# UNITED STATES PATENT AND TRADEMARK OFFICE

**Office Action Summary**

## **DETAILED ACTION**

(marked Martin Figure 3)

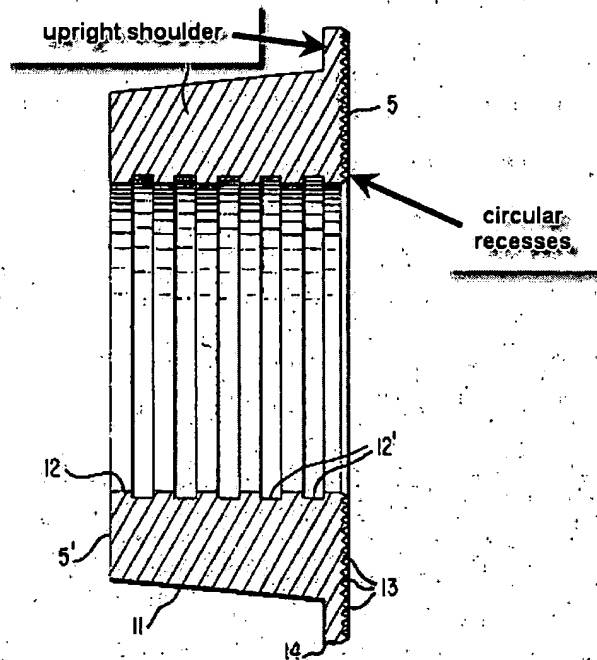
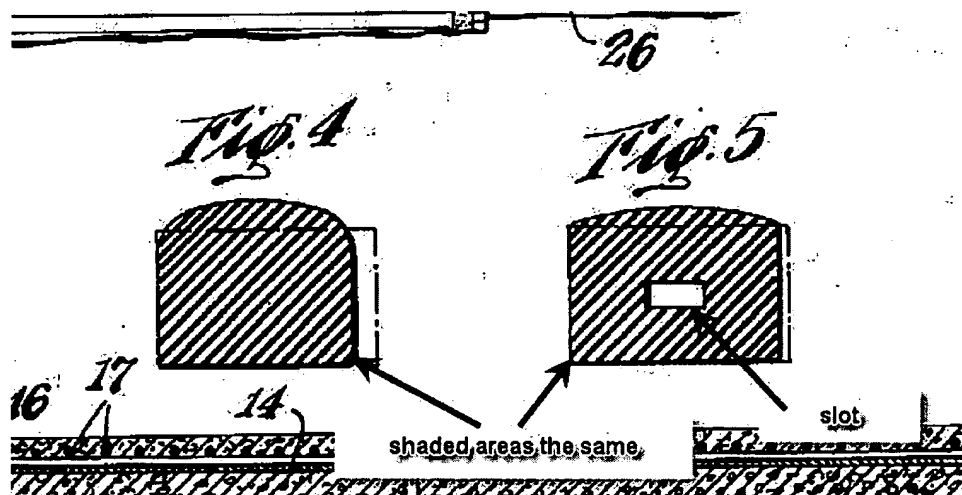
25. In regard to claim 28, Baker discloses the claimed invention except for the mounting ring having a circular recess for the gasket. Martin teaches a pipe coupling with a mounting ring, as observed in marked Figure 3 below, with circular recesses (13) to engage a gasket and improve sealing (column 2, lines 40-44). It would have been obvious to one having ordinary skill in the

26. In regard to claim 33, Baker discloses the claimed invention except for an upright shoulder extending around the end of the cone-shaped surface. Martin, in marked Figure 3 above, further teaches a mounting ring with an upright shoulder (14) to prevent the ring from being pulled through the mounting flange (column 2, lines 62-66). It would have been obvious to one having ordinary skill in the art at the time the invention was made to modify the mounting ring of Baker with an upright shoulder as taught by Martin to prevent the mounting ring from being pulled through the mounting flange.

(Milot et al Figure 1)

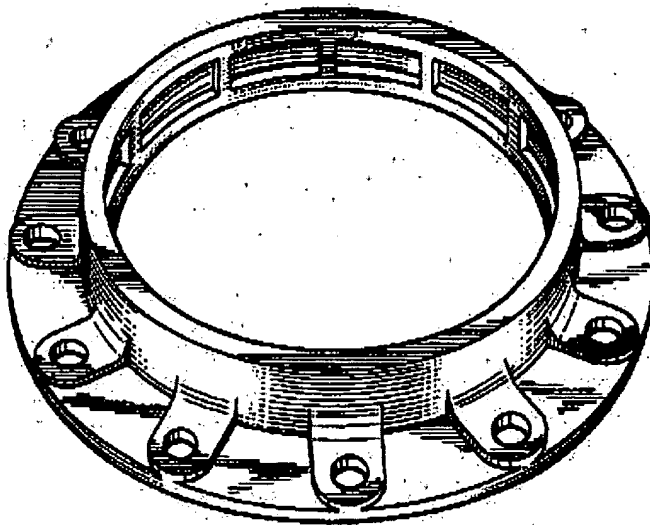
32. In regard to claim 36, Baker discloses the claimed invention except for the series of bores being partly surrounded by arcuate projections. Milot et al teach a flange in Figure 1, below, with arcuate projections partly surrounding the bores to buttress the flange against tensional bending when the bolts are tightened. As relates to flanges, it would have been obvious to one having ordinary skill in the art at the time the invention was made to provide the flange of Baker with arcuate projections partly surrounding the bores as taught by Milot et al to buttress the flange against tensional bending when the bolts are tightened.

(marked Risley Figures 27 and 29)

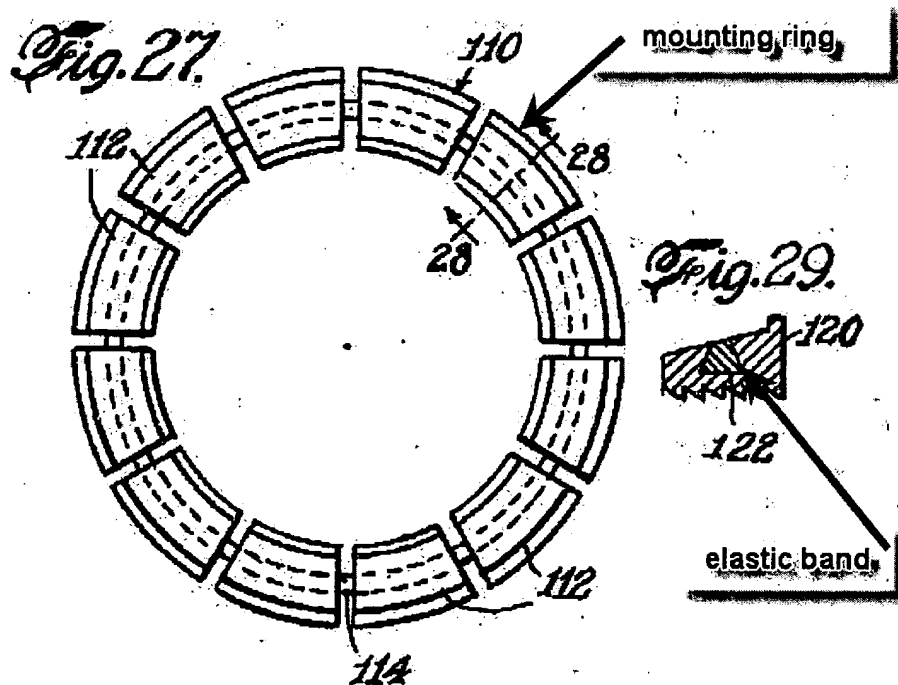
34. In regard to claim 37, Baker discloses the claimed invention except for the ring segments being held together by an elastic band. Risley teaches a pipe coupling with a multi-segment mounting ring in Figure 27, below, with an elastic band (122 as observed in Figure 29. below) holding the segments together to allow the segments to be moved radially inwardly into engagement with the pipe surface when compressed (column 6, lines 33-40). As relates to multi-segment mounting rings, it would have been obvious to one having ordinary skill in the art at the time the invention was made to fabricate the mounting ring of Baker with an elastic band as taught by Risley to allow the segments to be moved radially inwardly into engagement with the pipe surface when compressed.

(marked Seiler Figures 8 and 10)

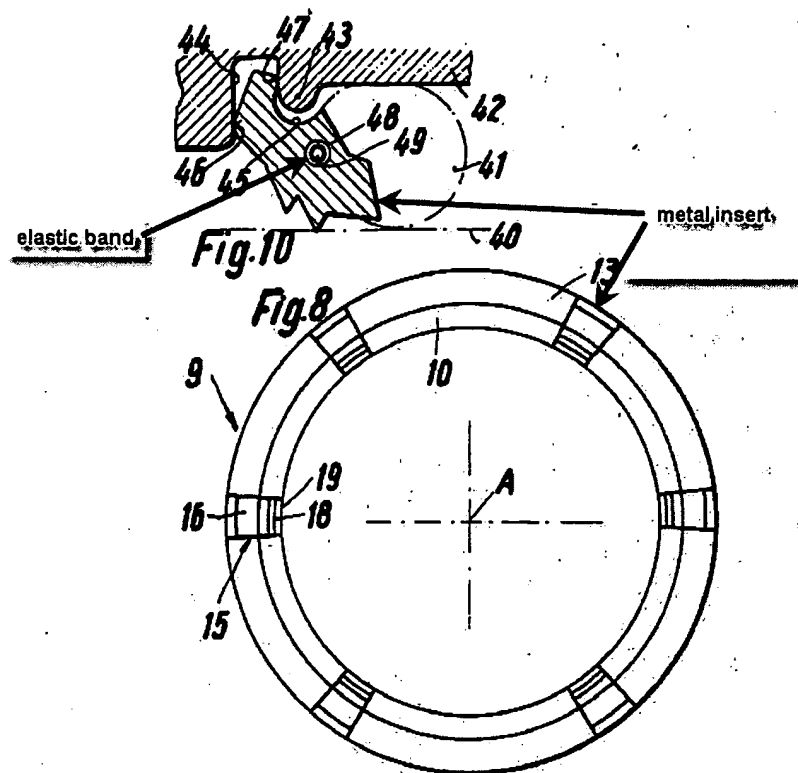
36. In regard to claim 38, Baker in view of Risley provide for the claimed invention except for metal inserts being interposed between adjacent segments. Seiler in Figures 8 and 10, below, teach placing metal insets (metal as shown by the crosshatching in Figure 8) as an anti-thrust provision in rings of pipe connections to secure the male end against thrust (column 1, lines 1-2, and column 1, line 68, through column 2, line 1). As relates to pipe connection rings, it would have been obvious to one having ordinary skill in the art at the time the invention was made to provide the segmented ring as provided by Baker in view of Risley with metal inserts interposed between adjacent segments as taught by Seiler to secure the male end against thrust.

37. In regard to claim 39, Seiler further teaches that the segments and inserts be held together by an elastic band threaded therethrough to secure the metal segments in the ring (column 6, lines 12-26). As relates to pipe connection rings, it would have been obvious to one having ordinary skill in the art at the time the invention was made to hold the segments and inserts of the segmented ring provided by Baker in view of Risley by an elastic band threaded therethrough as taught by Seiler to secure the metal segments in the segmented ring.
